CITY OF MANDAN, NORTH DAKOTA MAIN STREET WATER IMPROVEMENTS DISTRICT #39, WATER IMPROVEMENT PROJECT 96-2, PHASE III

Record Drawing

DATE: 2-14-97

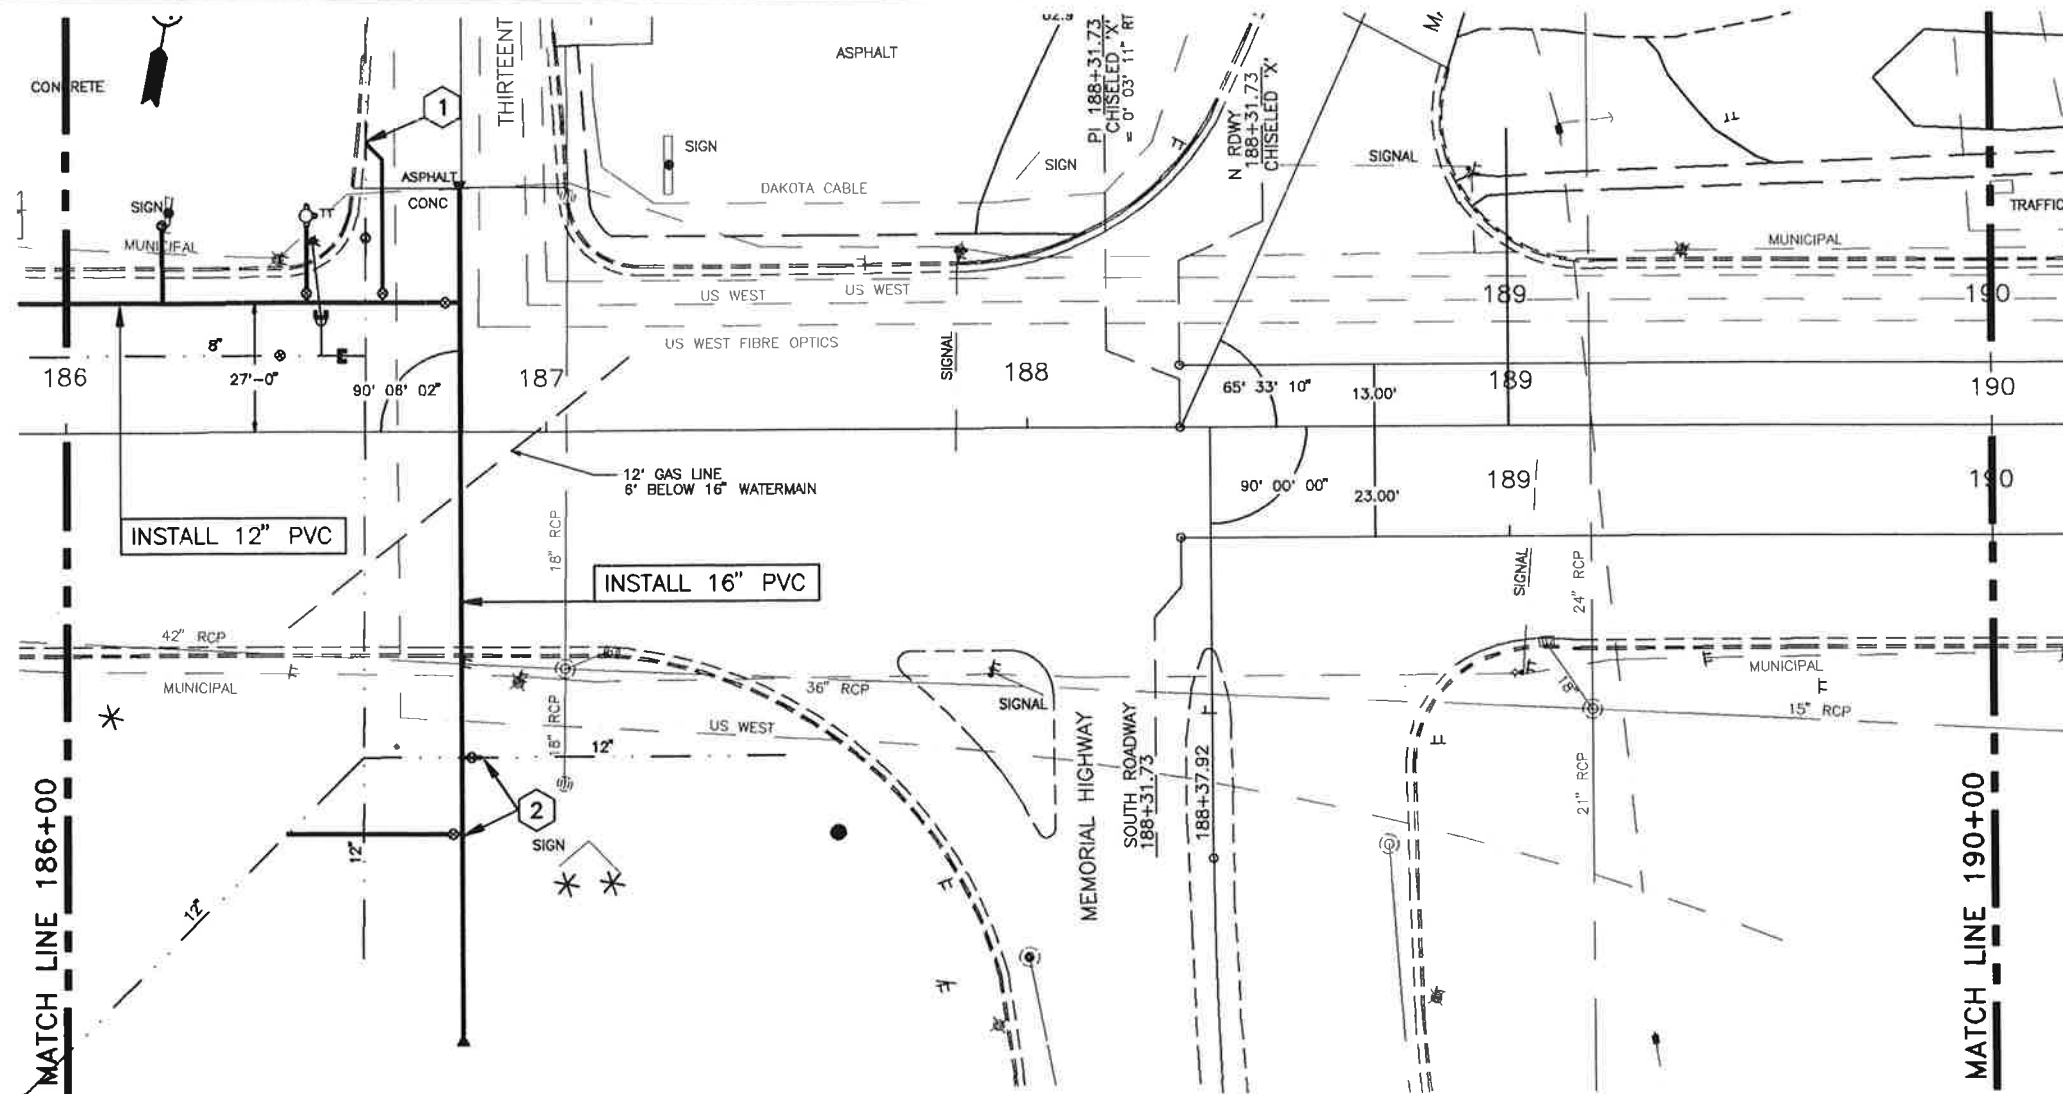
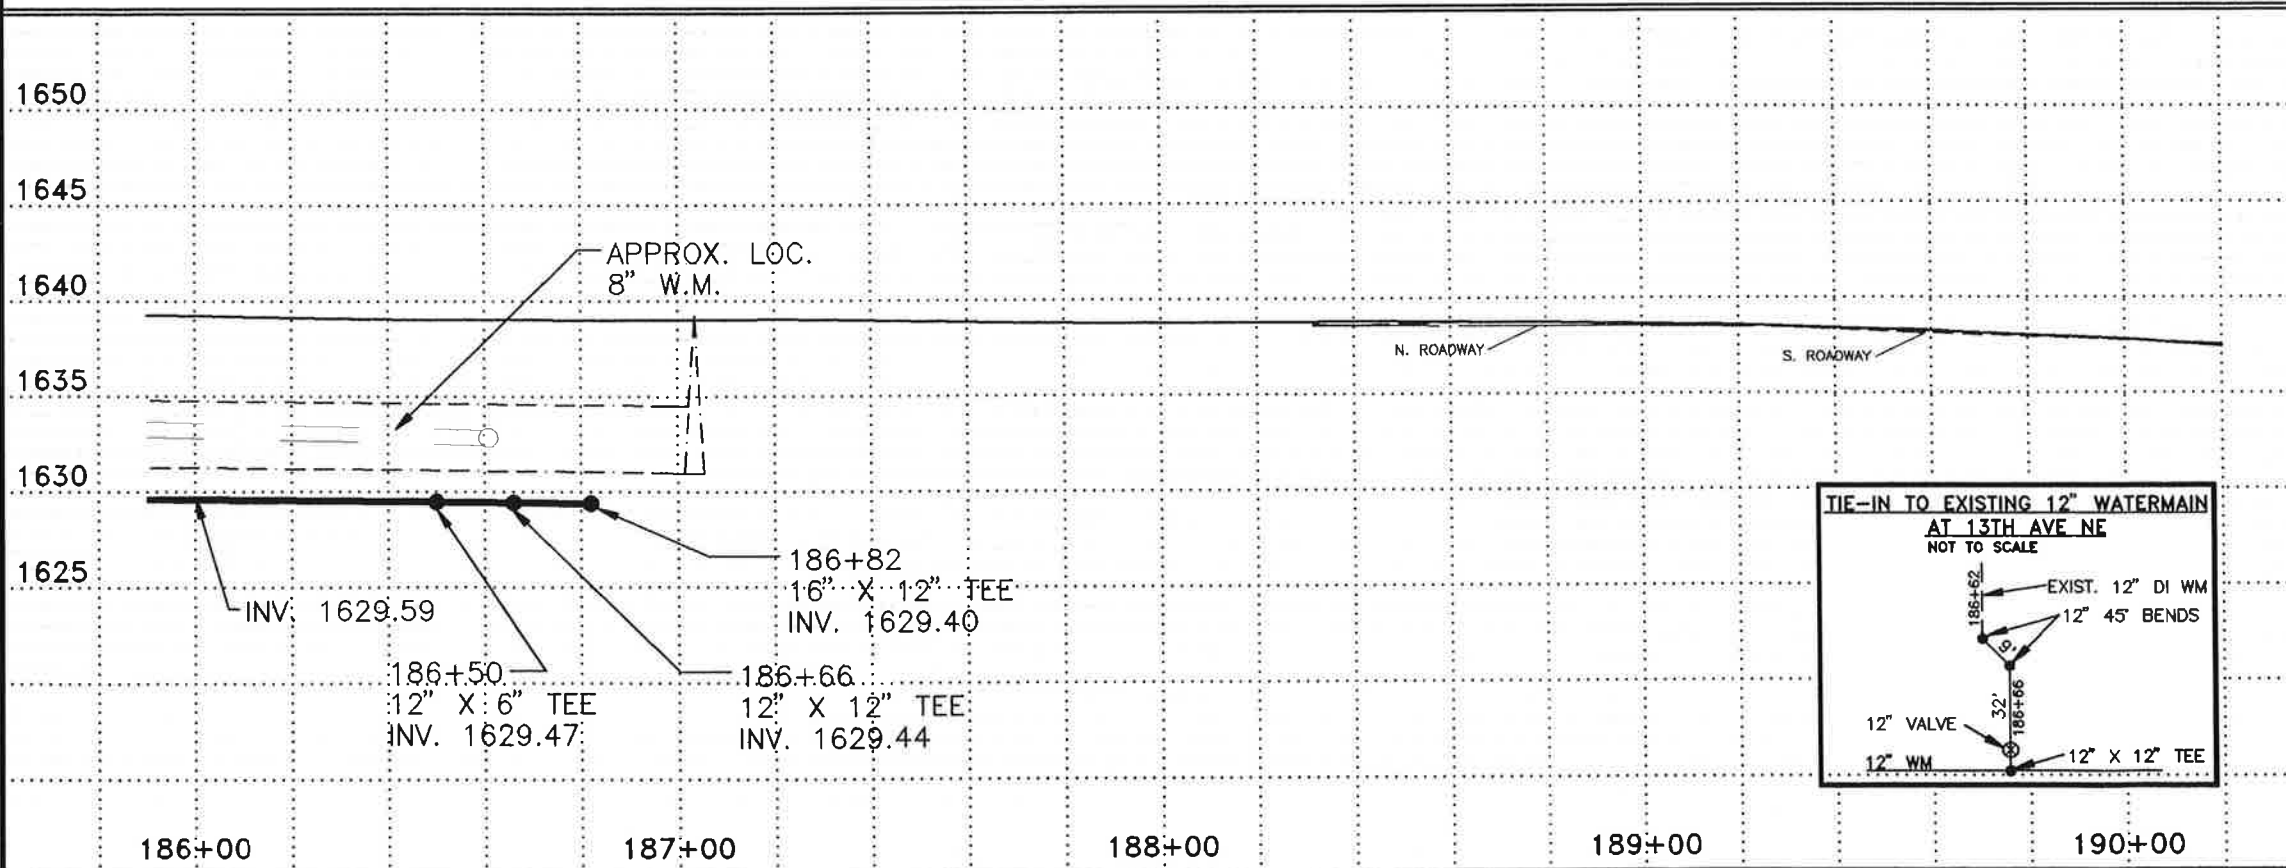
6" HYDRANT		
186+50 - 45' LT	1 EA	
GATE VALVE AND BOX, 6"		
186+50 - 29' 30" LT	1 EA	
GATE VALVE AND BOX, 8"		
186+79 - 120' RT	1 EA	
GATE VALVE AND BOX, 12"		
186+66 - 29' 30" LT	1 EA	
186+79 - 27' LT	1 EA	
+84 186+85 - 68' 11 1/2" RT	1 EA	
186+80 - 84' RT	1 EA	
WATERMAIN, 6" PVC		
186+50 - 27' LT TO 186+50 - 45' LT	18 LF	
WATERMAIN, 8" PVC		
186+47 - 120' RT TO 186+82 - 120' RT	35 LF	
WATERMAIN, 12" PVC		
186+00 - 27' LT TO 186+82 - 27' LT	82 LF	
186+66 - 27' LT TO 186+62 - 60' LT	32-33 LF	
186+82 - 68' 11 1/2" RT TO 187+04 - 68' 11 1/2" RT	4-22 LF	
186+45 - 84' RT TO 186+82 - 84' RT	37 LF	
WATERMAIN, 16" PVC (OR 18")		
186+82 - 50' LT TO 186+82 - 126' RT	176 LF	
FITTINGS, DUCTILE IRON		
186+47 - 120' RT	8" 1/8 BEND	45 LBS
186+50 - 27' LT	12" X 6" TEE	115 +23 LBS
186+62 - 60' LT	2 - 12" 1/8 BENDS	184 LBS
186+66 - 27' LT	12" X 12" TEE	178 +64 LBS
186+82 - 27' LT	16" X 12" TEE	281 590 LBS
186+82 - 50' LT	16" PLUG	93 150 LBS

186+82 - 68' 11 1/2" RT	16" X 12" TEE	281 590 LBS
186+82 - 84' 120' RT	16" X 8" TEE	281 550 LBS
186+82 - 126' RT	16" PLUG	93 150 LBS
187+04 - 115' RT	12" 1/32 BEND	65 LBS
186+53 - 24' LT	6" PLUG	18 LBS
186+57 - 18' LT	6" PLUG	18 LBS

WATER SERVICE LINE 1-1/2" COPPER		
186+20 - 27' LT TO 186+20 - 43' 40" LT	16 +13 LF	
WATER SERVICE CONNECTION 1-1/2"		
186+20 - 27' LT	1 EA	
CURB STOP AND BOX 1-1/2"		
186+20 - 43' 40" LT	1 EA	
REMOVE HYDRANT		
186+50 - 35' LT	1 EA	
POLYSTYRENE INSULATION		
186+82 - 50' RT	64 BDFT

1 CONNECTED
CONNECT NEW 12" TO EXISTING 12"
GOING NORTH ONCE EXISTING 12"
UNDER MAIN CAN BE ABANDONED

2 CONNECTED
CONNECT NEW LINE TO EXISTING
LINE

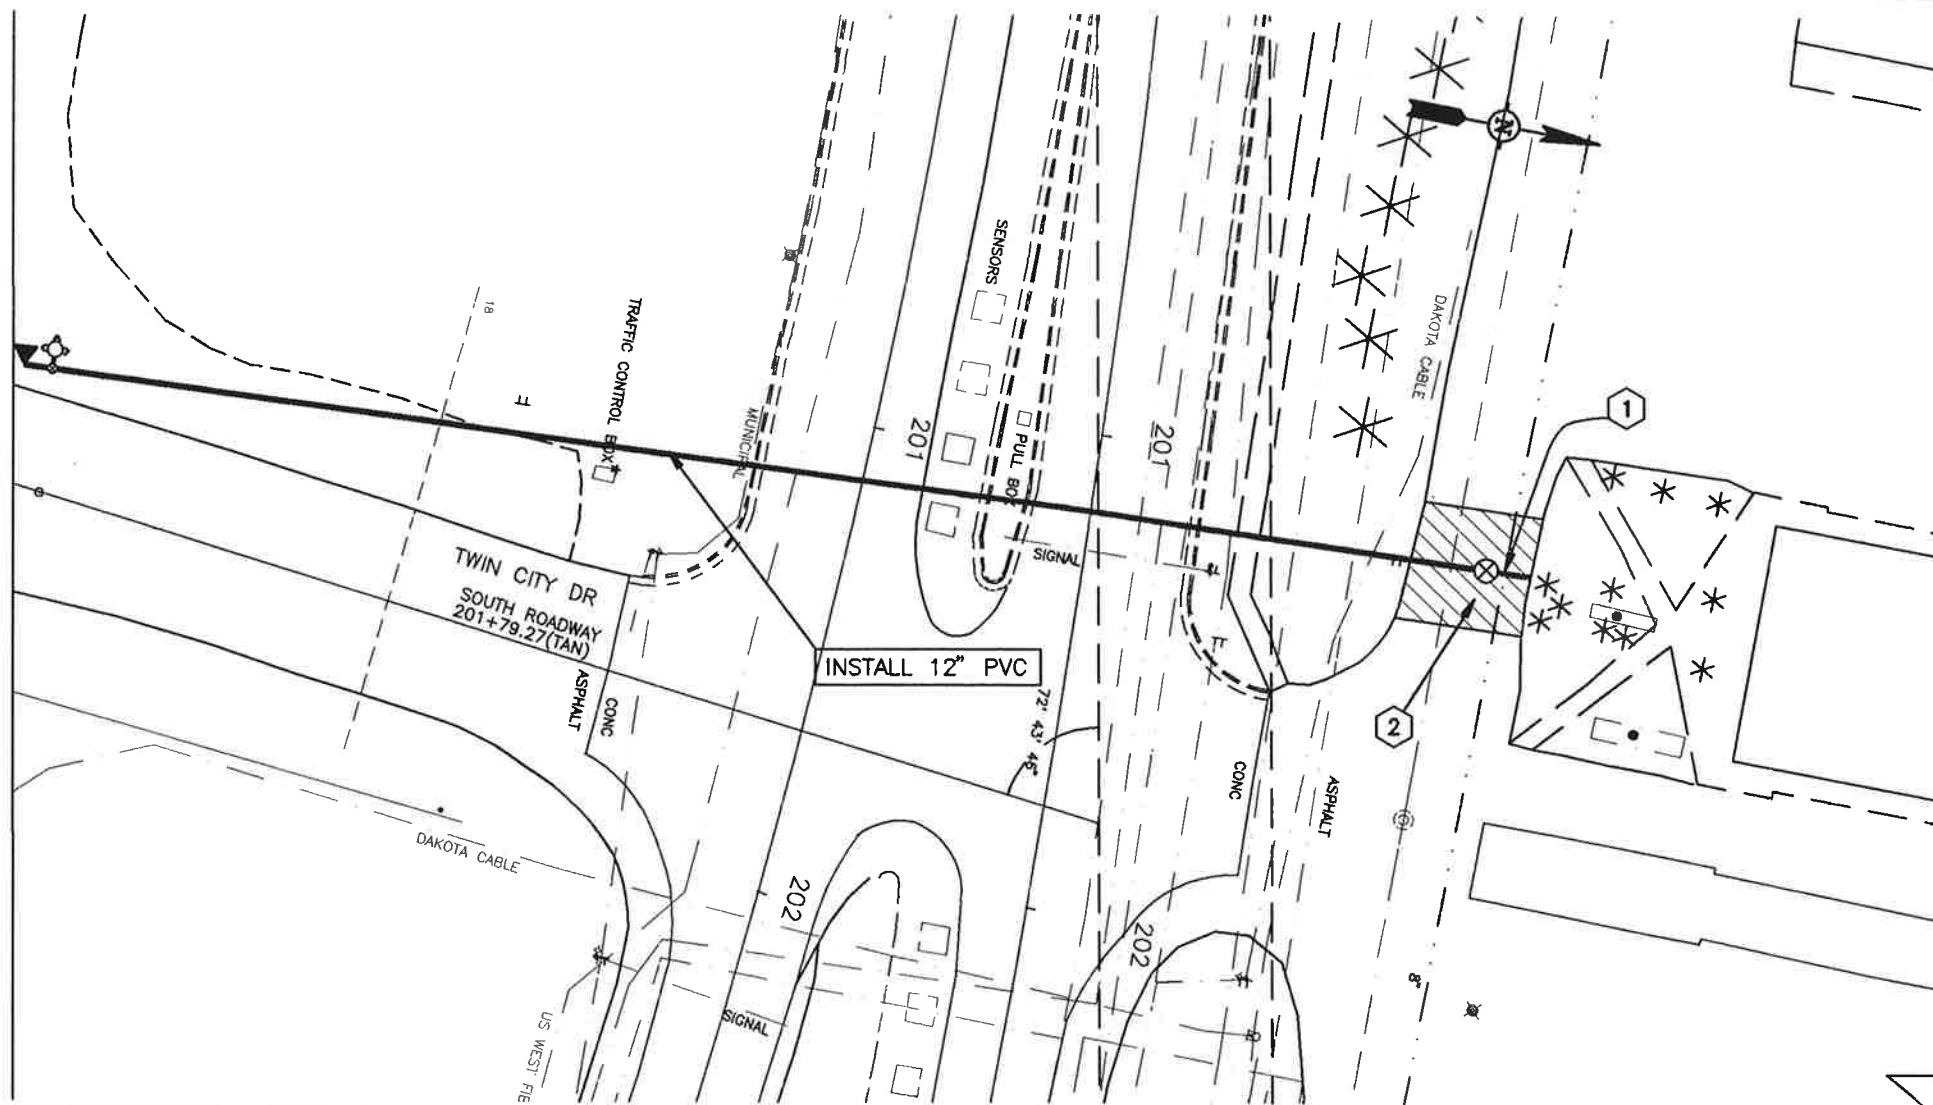
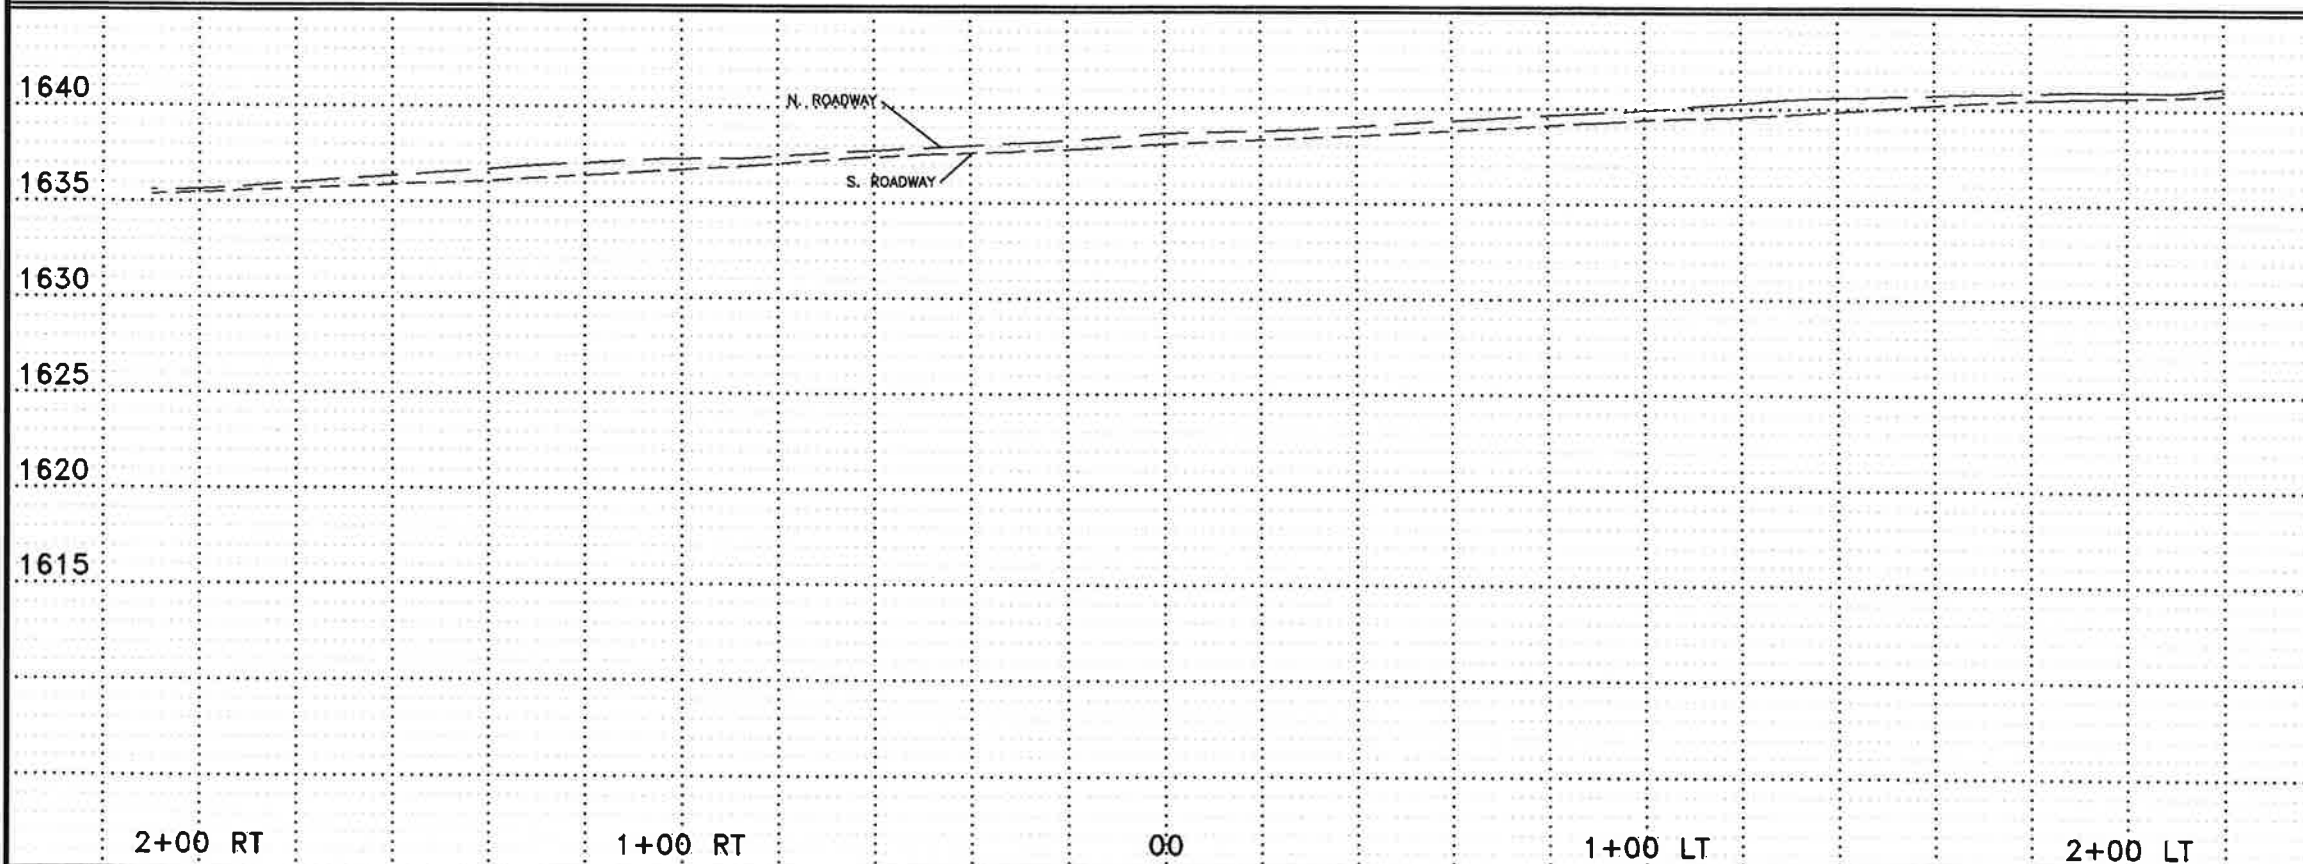
6" HYDRANT		
201+12 - 218' RT OF N RDWY C	1 EA	
GATE VALVE AND BOX, 6"		
201+18 - 218' RT OF N RDWY C	1 EA	
GATE VALVE AND BOX, 12" 8"		
201+18 - 83' LT OF N RDWY C	1 EA	
WATERMAIN, 6" PVC		
201+12 - 218' RT TO 201+18 - 218' RT	6 LF	
WATERMAIN, 12" PVC		
201+18 - 86' LT TO 201+18 - 224' RT	310 LF	
FITTINGS, DUCTILE IRON		
201+18 - 86' LT	8" X 12" TEE	123 137 LBS
201+18 - 218' RT	12" X 6" TEE	123 LBS
201+18 - 224' RT	12" PLUG	49 LBS
201+18 - 83' LT	12" TO 8" REDUCER	64 LBS

- ① CUT IN 12" X 8" TEE
- ② ~~REMOVE~~ ~~REPLACE~~ ~~REMOVE AND REPLACE~~ ASPHALT PAVEMENT AS REQUIRED, ALL COSTS INCIDENTAL
